UNITED STATES PATENT AND TRADEMARK OFFICE

APPLICATION NO.	FILING DATE	FIRST NAMED INVENTOR	ATTORNEY DOCKET NO.	CONFIRMATION NO.
10/766,391	01/28/2004	Douglas Dombrowski	DP-311282	3331

Office Action Summary

ATTACHMENT # 1

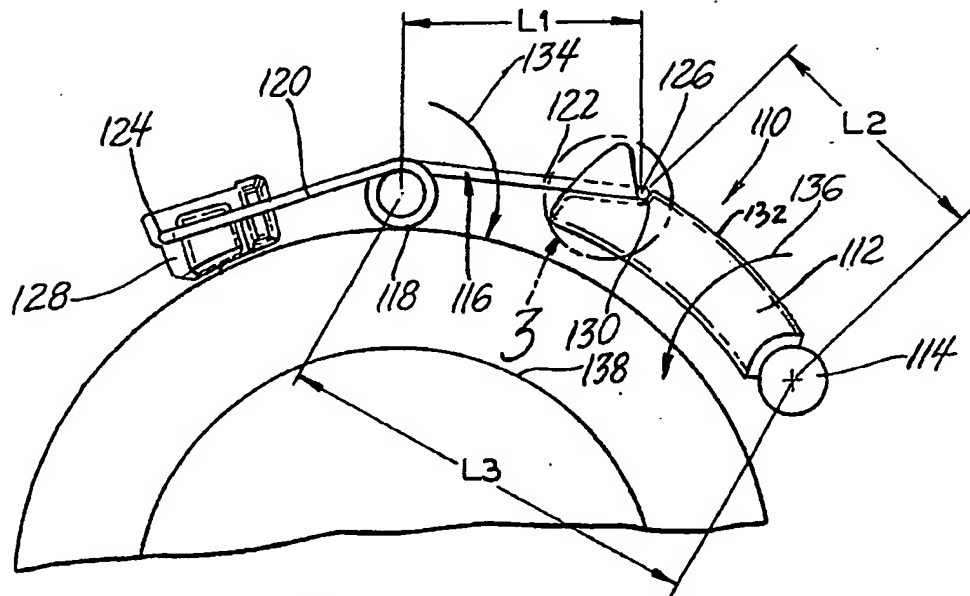
4. Claims 1 and 2 are rejected under 35 U.S.C. 102(a) as being anticipated by admitted prior art (Applicant's Fig. 1).

Regarding claim 1, admitted prior art teaches a two position, spring biased lever system comprising a lever 12 that pivots on a support 14 between a first (up) position and a second (down) position, and a spring 16 having an arm 20 that biases the lever 12 toward the second position, the arm 20 engaging the lever 12 to hold the lever 12 in the first position.

Regarding claim 2, admitted prior art teaches a two position, spring biased lever system comprising a lever 12 that pivots on a support 14 between a first (up) position and a second (down) position, and a spring 16 having a spring arm 20 that engages a notch (unnumbered. See Attachment 1) in the lever 12 to hold the lever 12 in the first position while biasing the lever 12 toward the second position when the lever 12 is in the first position.

ATTACHMENT # 2

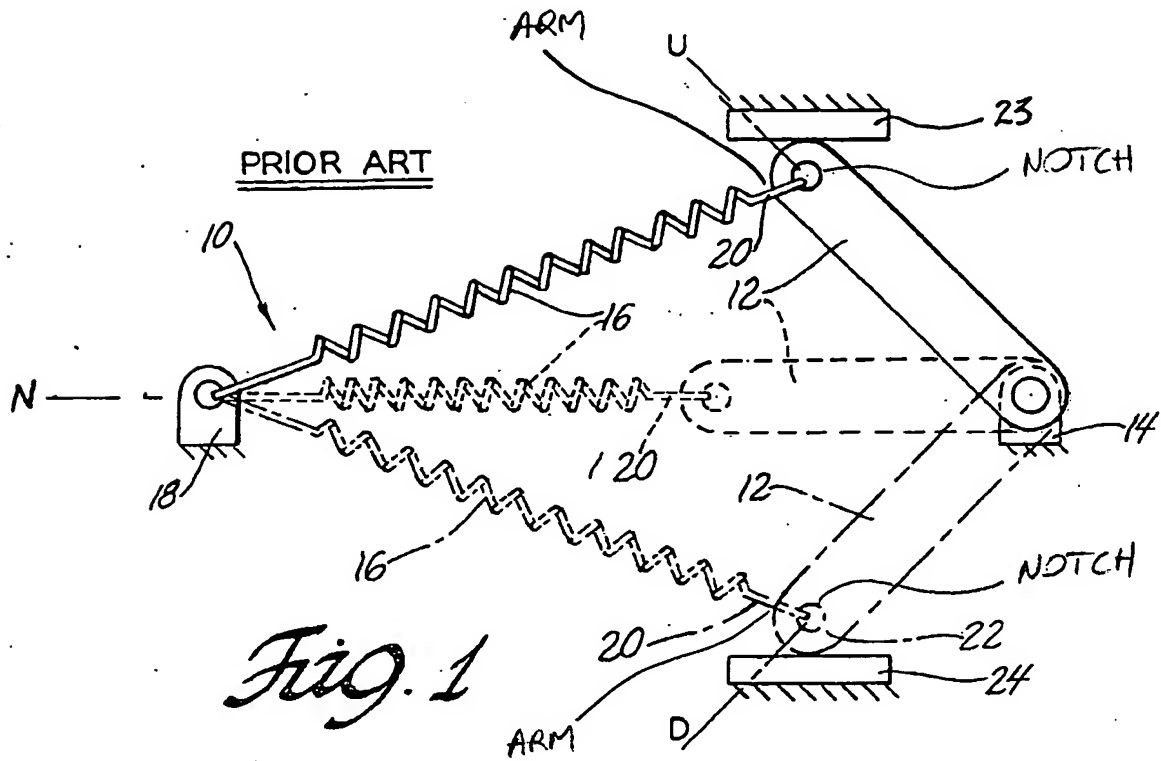
Regarding claims 6 and 7, the spring arm 34a has a length L-1 (see Attachment 2) measured from its pivot to the distal end, wherein the lever has a length L-2 (Att. 2) measured from its pivot to the notch, and wherein the system has a length L-3 (Att.) measured from the

pivot of the spring arm to the pivot of the lever and wherein the sum of the length L-1 and the length L-2 exceeds the length L-3 when the lever is in the first position as seen in Fig. 1.
